## **AMENDED APPLICATION CLASS 1**

Planning law – application to modify development consent granted by the Court (s 4.55(8)  
*Environmental Planning and Assessment Act 1979*)

Application to modify the development consent to DA55/19 for the land at 5 Bay View Street, Lavender Bay granted by the Land and Environment Court on 3 September 2020 by *Camuglia v North Sydney Council* [2020] NSWLEC 1406 (proceedings 2019/268493) which approved the demolition of existing structures and construction of a new residential flat building containing three units, a new garage structure and associated works (**the approved development consent**).

The Application seeks the ~~removal of the step in the roof and the~~ deletion of condition A2 of the approved development consent which requires the roof ridge height and surrounding parapet for the structures at Bay View Street level, comprising the car lift, visitor's car space and pedestrian entry lift and stairwell, be reduced to RL 22.00.

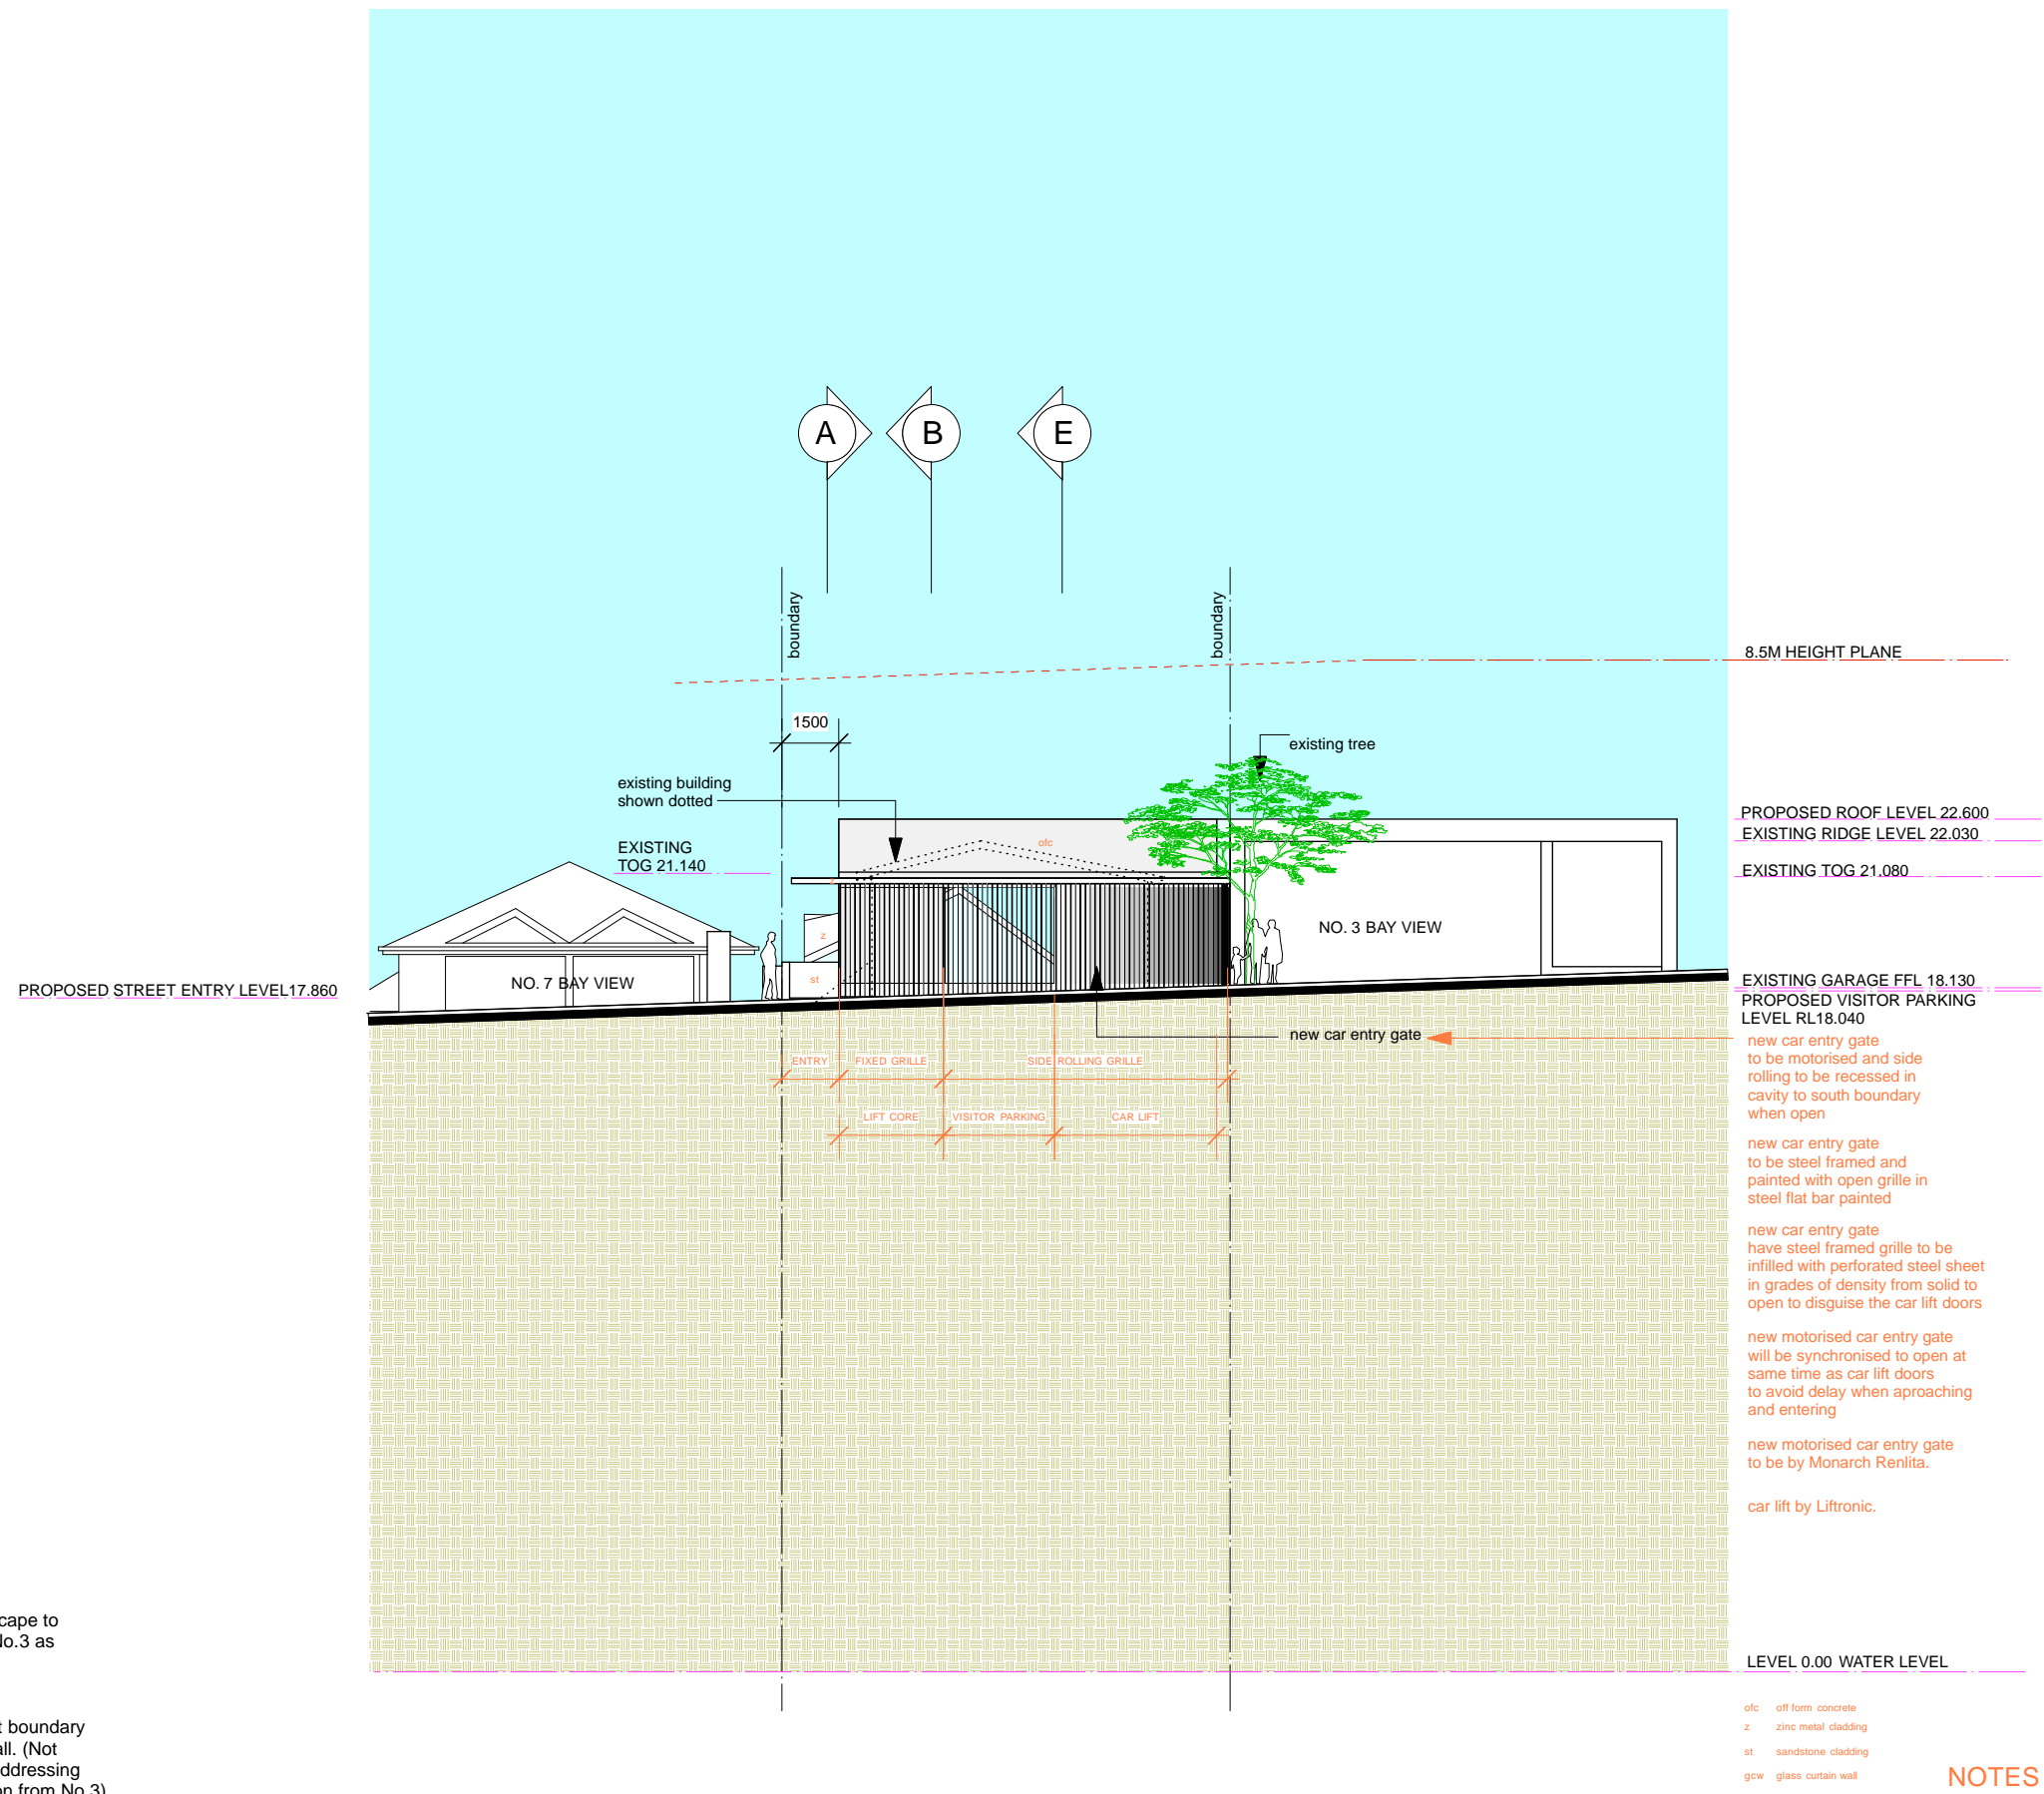
- A** Indicates revisions to roofscape to reduce overshadowing to No.3 as requested by council.
- B** Indicates revision to stair at boundary to No.3 adding retaining wall. (Not requested by council, but addressing concern outlined in objection from No.3)

8.5M HEIGHT PLANE

PROPOSED ROOF LEVEL 22.600  
EXISTING RIDGE LEVEL 22.030  
EXISTING TOG 21.080

<b>MCK ARCHITECTS</b> <b>STUDIO 401, 104 COMMONWEALTH STREET</b> <b>SURRY HILLS NSW 2010 TEL 02 9211 4146</b>	<b>PROPOSED APARTMENTS AT 5 BAY VIEW STREET LAVENDER BAY</b> <b>FOR YOLANDA CAMUGLIA</b>	<b>SOUTH-EAST ELEVATION</b> 1:200 @ A3; 1:100 @ A1 DRAWN - MC	 23 APRIL 2020 JOB NO. 1911	<b>SK07</b>

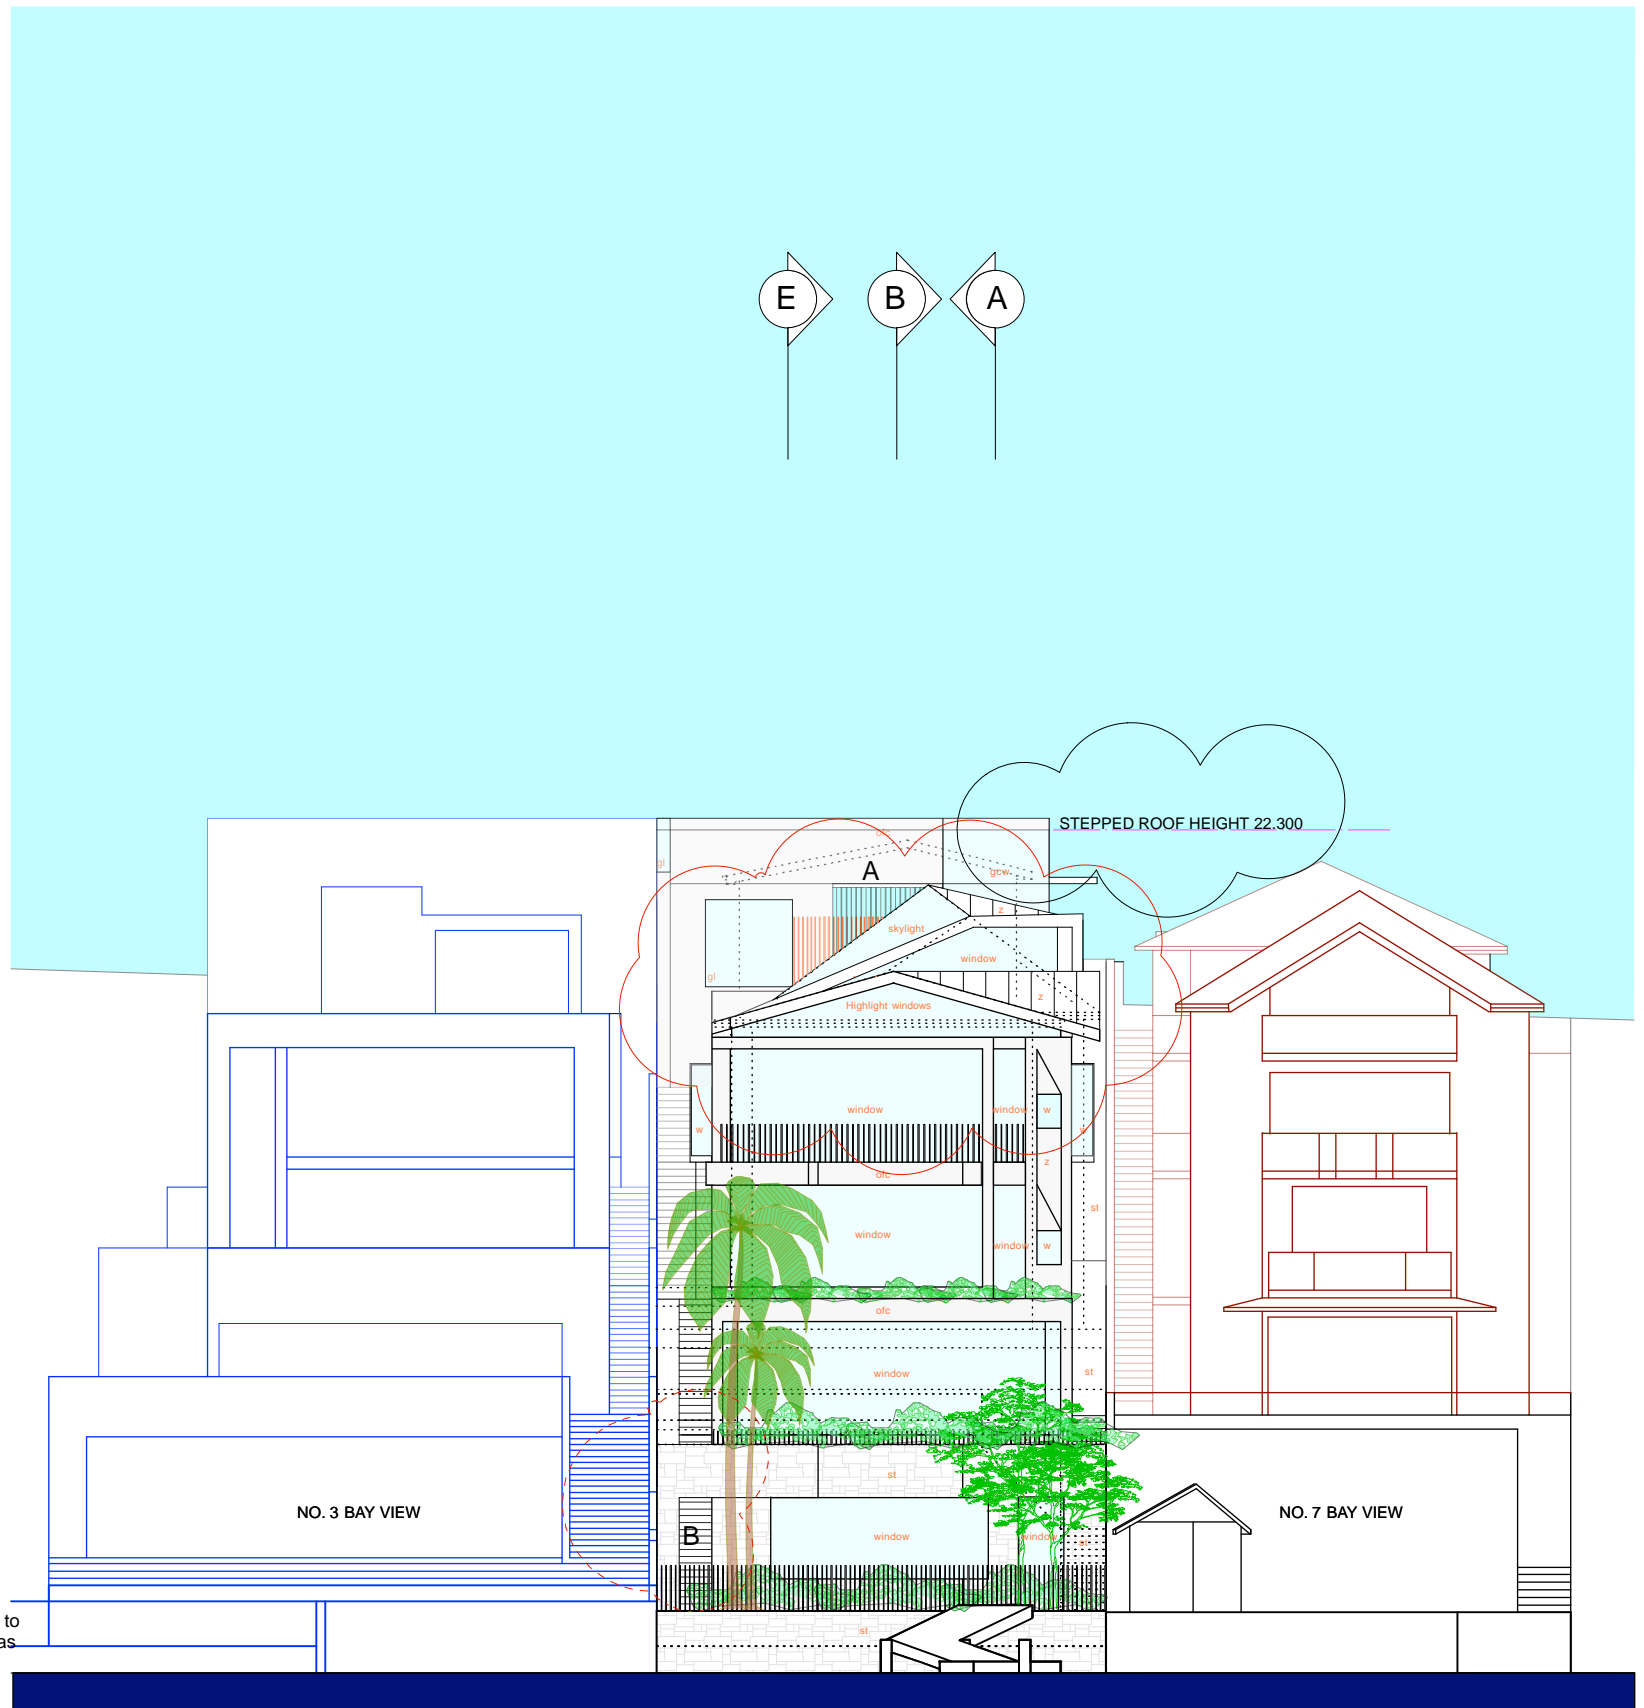
**A** Indicates revisions to roofscape to reduce overshadowing to No.3 as requested by council.

**B** Indicates revision to stair at boundary to No.3 adding retaining wall. (Not requested by council, but addressing concern outlined in objection from No.3)

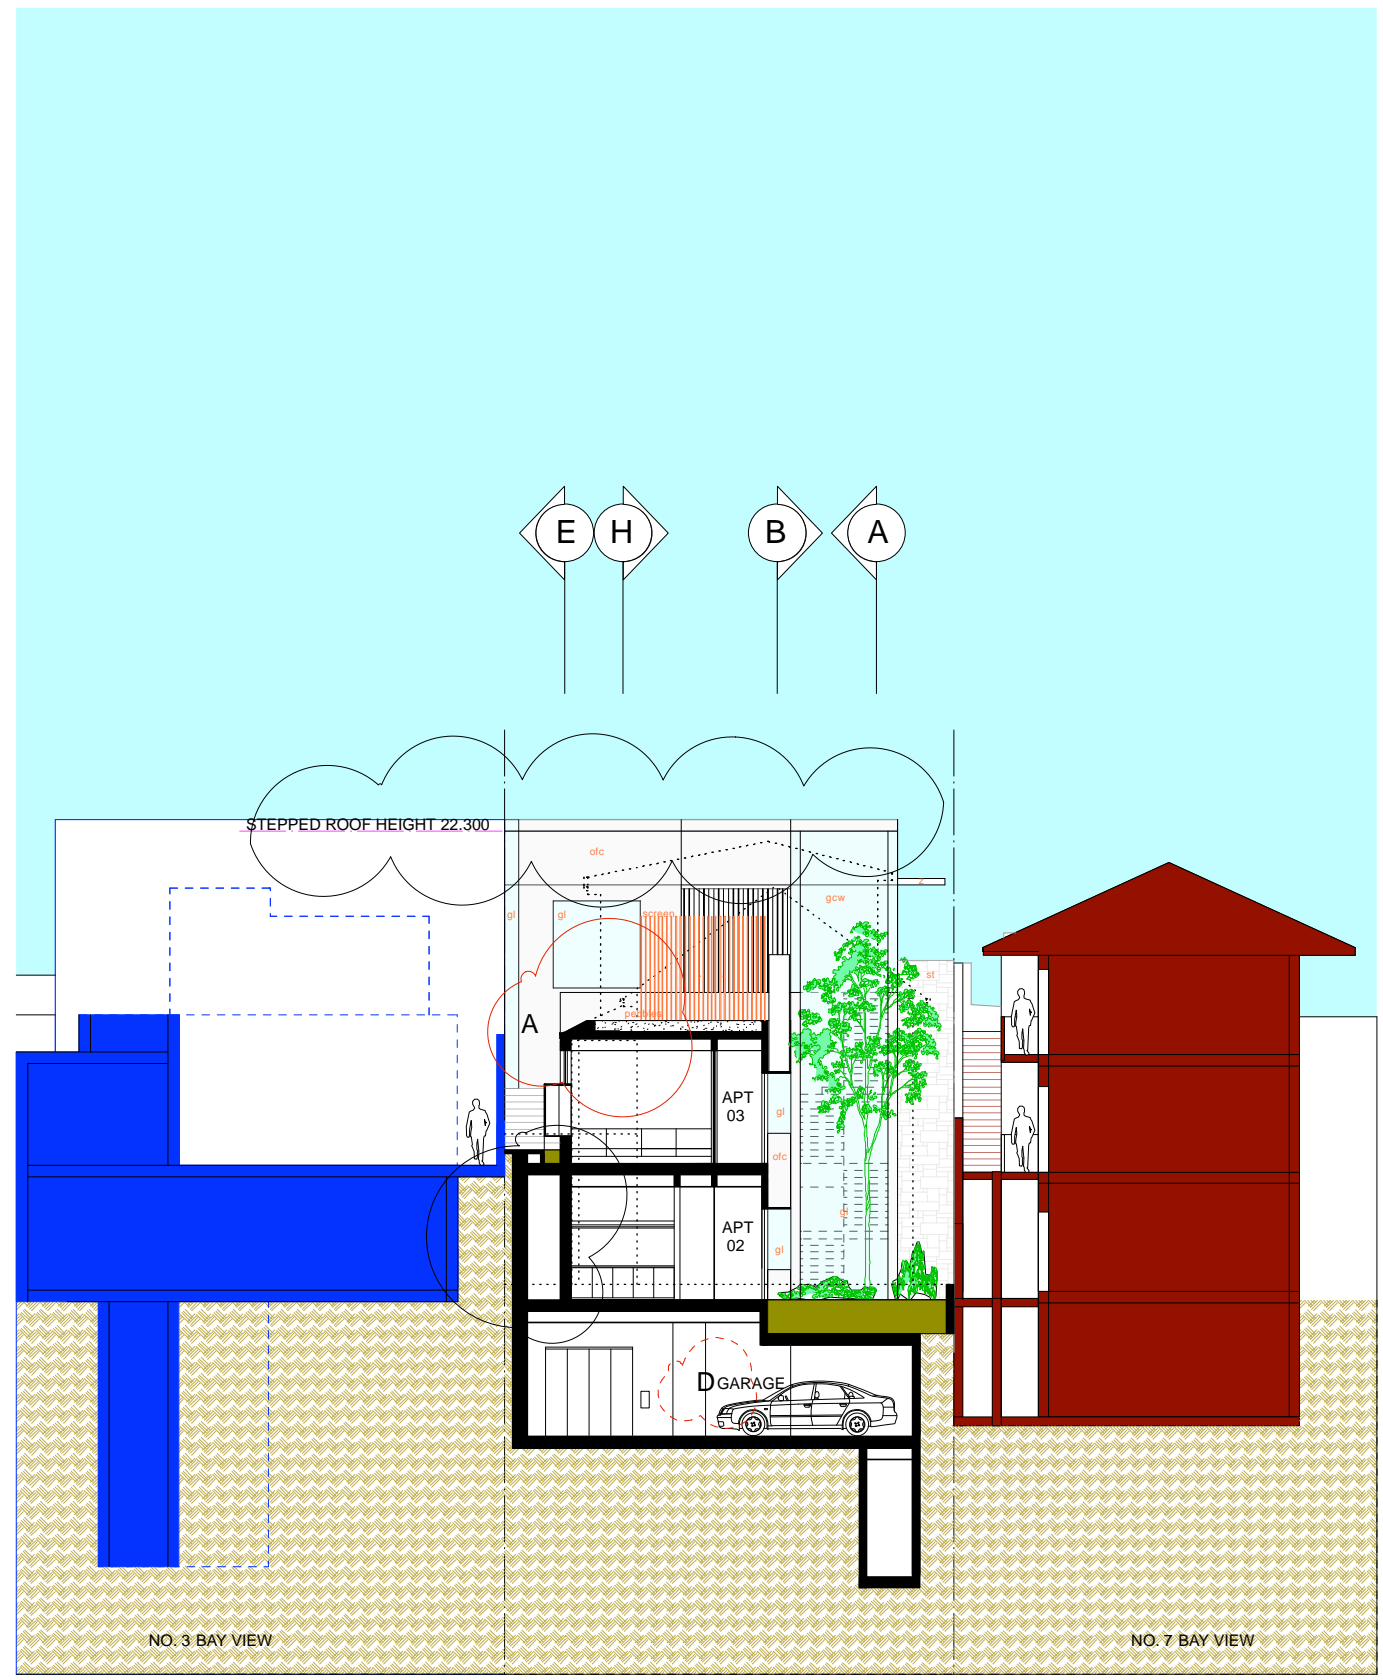
**A** Indicates revisions to roofscape to reduce overshadowing to No.3 as requested by council.

**B** Indicates revision to stair at boundary to No.3 adding retaining wall. (Not requested by council, but addressing concern outlined in objection from No.3)

Denotes changes on 20/4/20 following advice from Structural Engineer AND stepping of roof to street level on 23/4/20
